Attn: Shivesh Singh, Department of Planning
23 Bridge St, Sydney 2000

RE: Scottish Hospital Proposal, Paddington NSW
Ref # MP09_0016

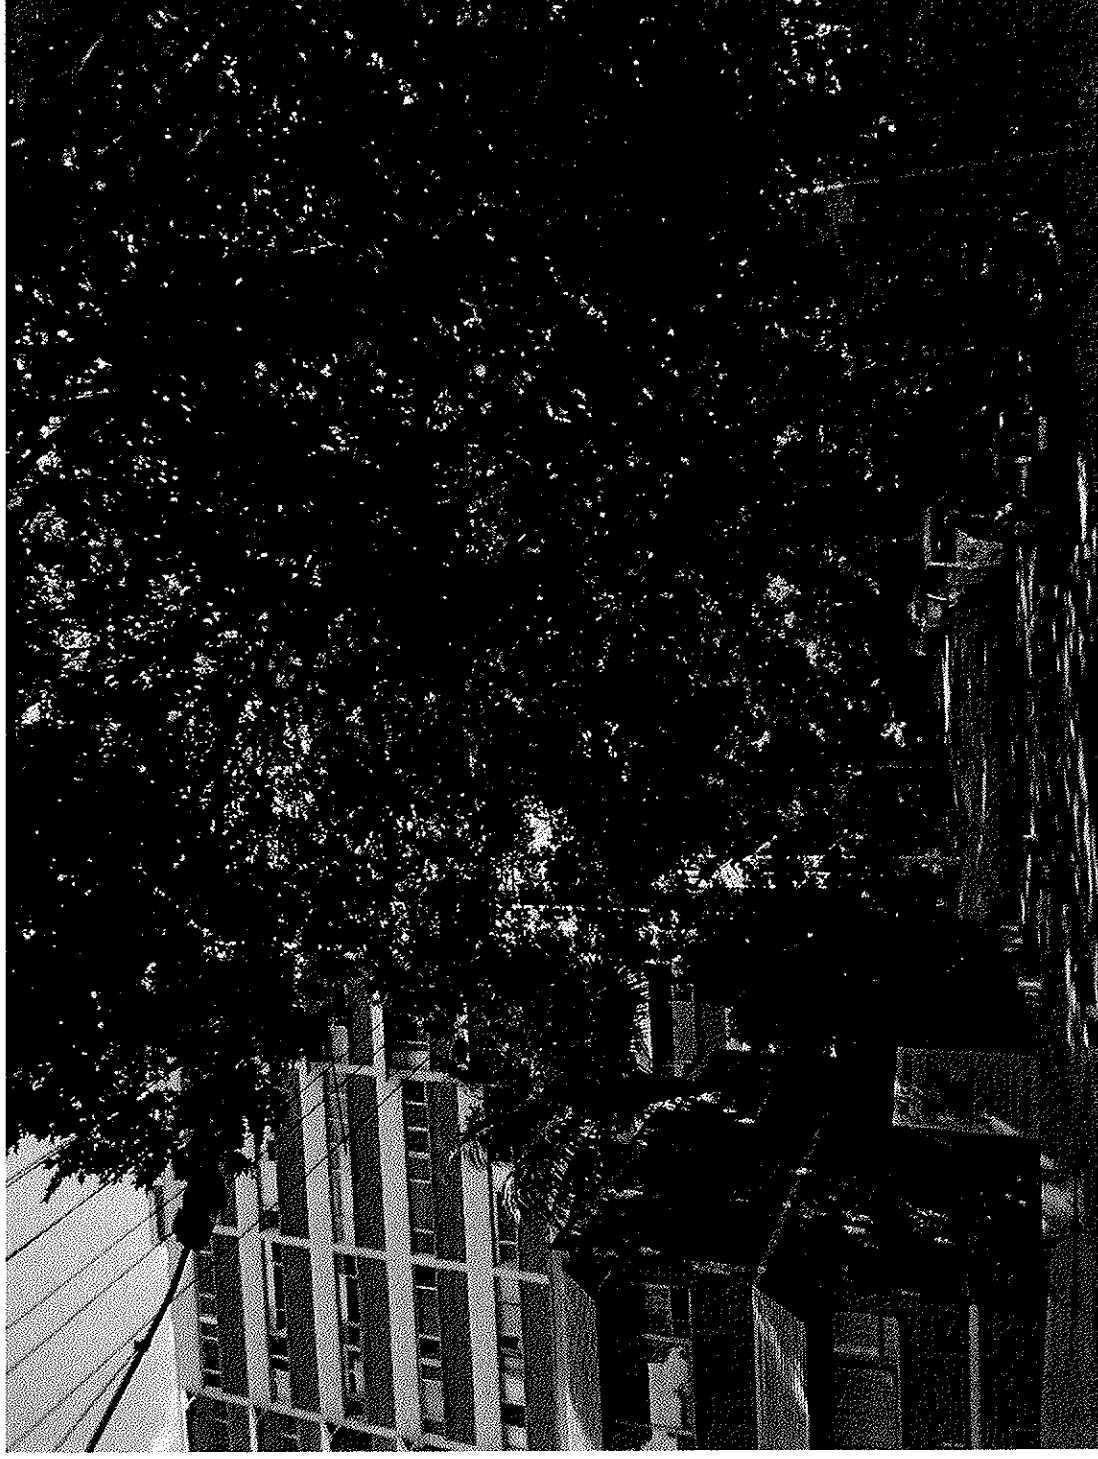
Currently a significant neighborhood view exists down Glen Street to the mature trees on Stephen Street. The placement of the ILU building at the base of Glen St does not allow for retention of the Woollahra TPO protected trees, additionally the placement of ILU Building appears part way across the intersection of Stephen and Glen Sts thereby providing a poor built form termination to Glen St.

The proposed fracturing and stepping of building form designed to "minimise" the impact of height creates an inappropriate architectural response. This is particularly apparent when nearly 90 trees are removed, exposing all this large development to public view. Proposed new plantings are actually large shrubs (proposed Blueberry Ash).

- This principle has been adhered to on other parts of the site, but has been disregarded for Stephen St. The proposal will place 5 to 6 storey buildings along the street edge with minimal setbacks, and in doing so remove every existing tree along the streetscape and replace them with shrubs
